Re: *Addendum No. 1*
Evergreen Cemetery Improvements
Village of Chagrin Falls

Date: March 26, 2025

EVERGREEN CEMETERY STREAM DAYLIGHTING AND IMPROVEMENTS

6A

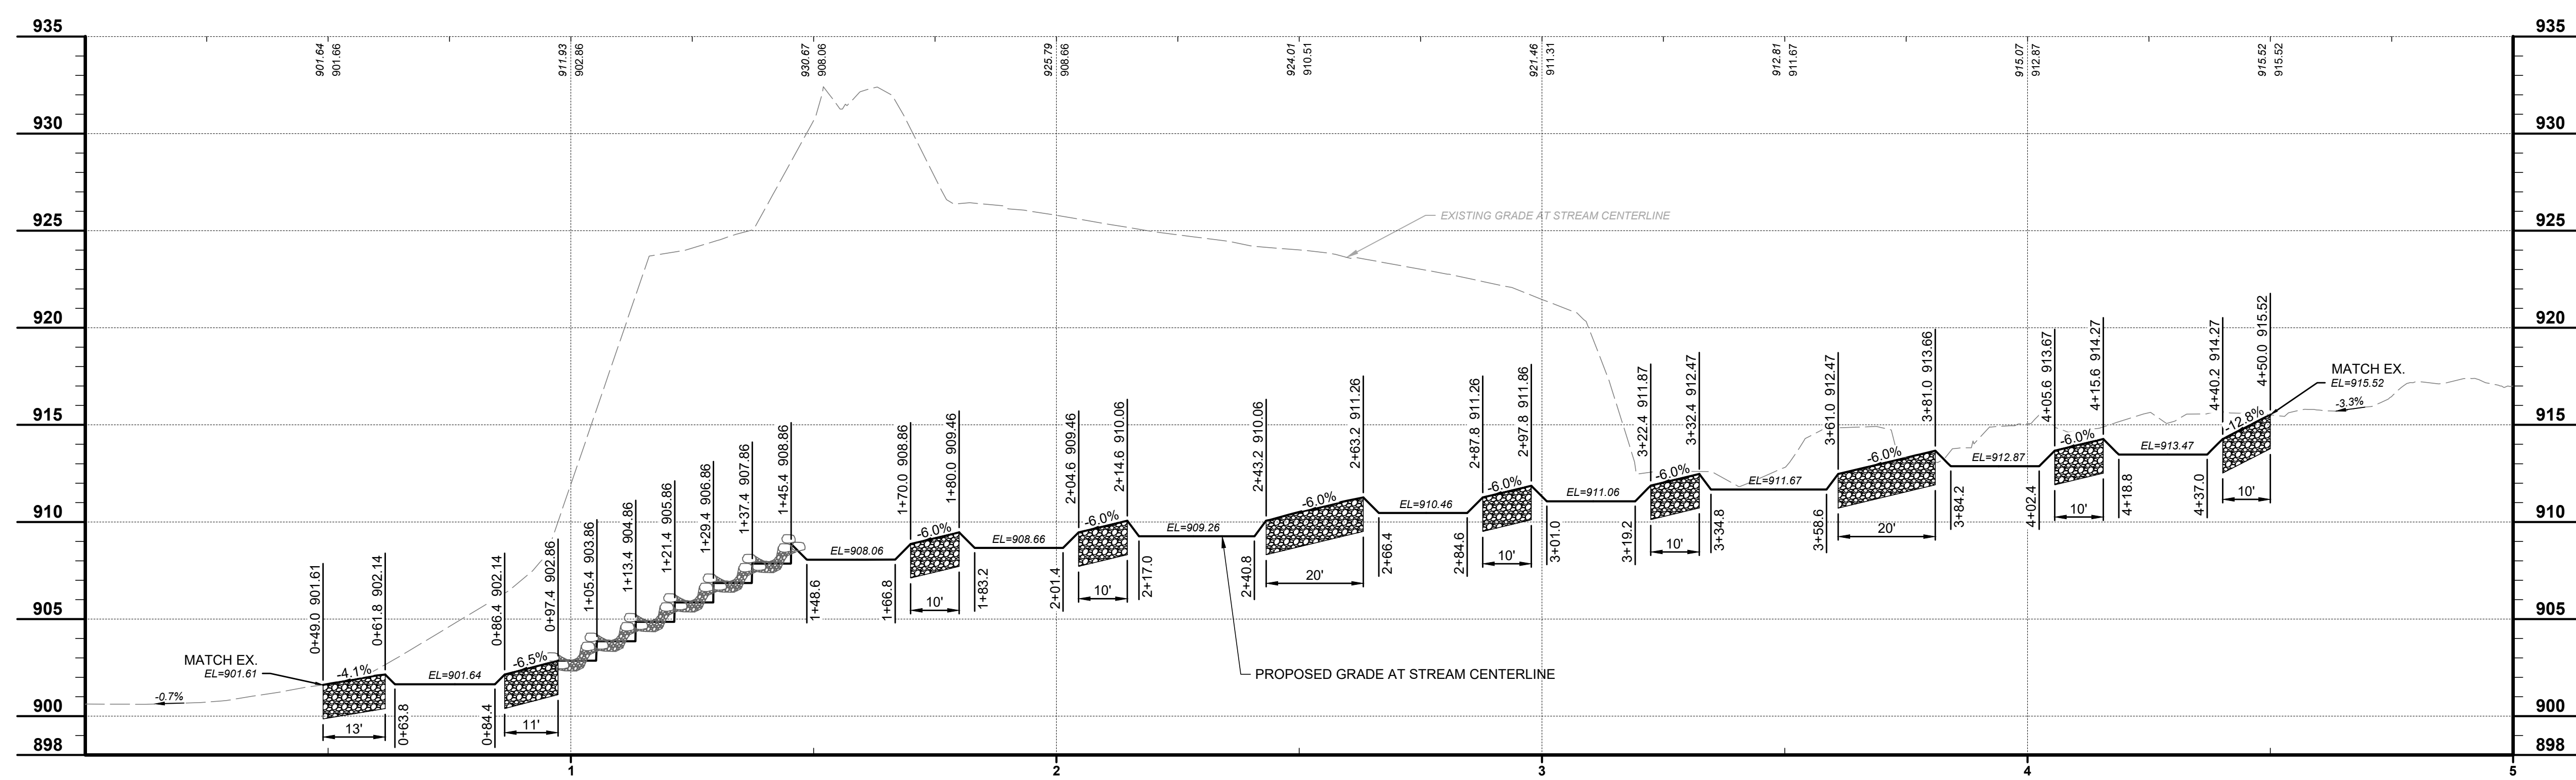
Q1. *Please clarify Part A, Part B, and grading alternates.*

Replace plan sheet 6 with the enclosed plan sheet 6A.

ISSUED FOR:	REVIEW	NO	REVISION	DATE
			UPDATE NORTH SIDE GRADING AND CALLOUTS	3/26/2025
ISSUE DATE:	3/26/2025			
SCALE:	AS SHOWN			
DESIGNED BY:	AAC			
DRAWN BY:	AAC			
CHECKED BY:	TRL

A1. Part A refers to the stream daylighting portion of the project (area in blue on plan sheet 6A) while Part B refers to grading and improvements adjacent to the stream daylighting (areas in red on plan sheet 8). Part B Grading Improvements includes the grading on the north side of the stream restoration and stockpiling the remaining suitable soil on the south side of the stream (plan sheet 8). Alternate 1 includes grading on the south side of the stream and stockpiling the remaining soil on the south side of the stream as well (plan sheet 9). Alternate 2 involves grading to the base bid grading plan (plan sheet 8) and removing all remaining soil, leaving no stockpile onsite.
